Road Safety Audit Stage 3

A458 / Ridout Rd Cross Houses Shrewsbury

Project Name:	A458 / Ridout Rd Cross Houses Shrewsbury
Project Number:	SRSS-019
Report Title:	Road Safety Audit Stage 3
Report Number:	Report SCC/2022/002

Photograph 5: Build up of detritus material on circulatory carriageway

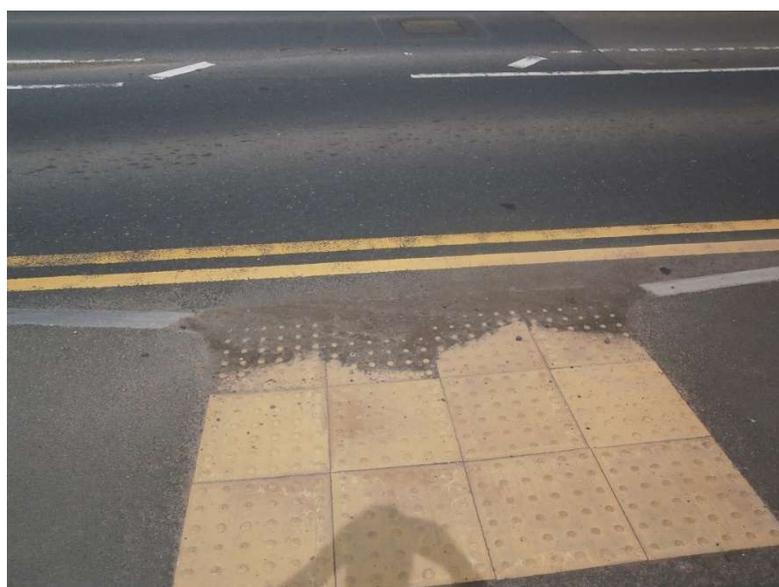
Location: Circulatory carriageway between A458 and Ridout Road.

Summary: Risk of loss of control collisions.

The kerb alignment and over run area for the roundabout has resulted in a large expanse of carriageway which is continuously unused. This has led to a build up of detritus material lying within the circulatory carriageway. This may cause some vehicles to lose control, particularly powered two wheeled vehicles who may momentarily lose control with the rider becoming unseated. This could result in injury to vulnerable road users

The road surface around this junction should be subject to routine maintenance regime of being regularly swept to keep the circulatory carriageway free from a build-up of detritus material.
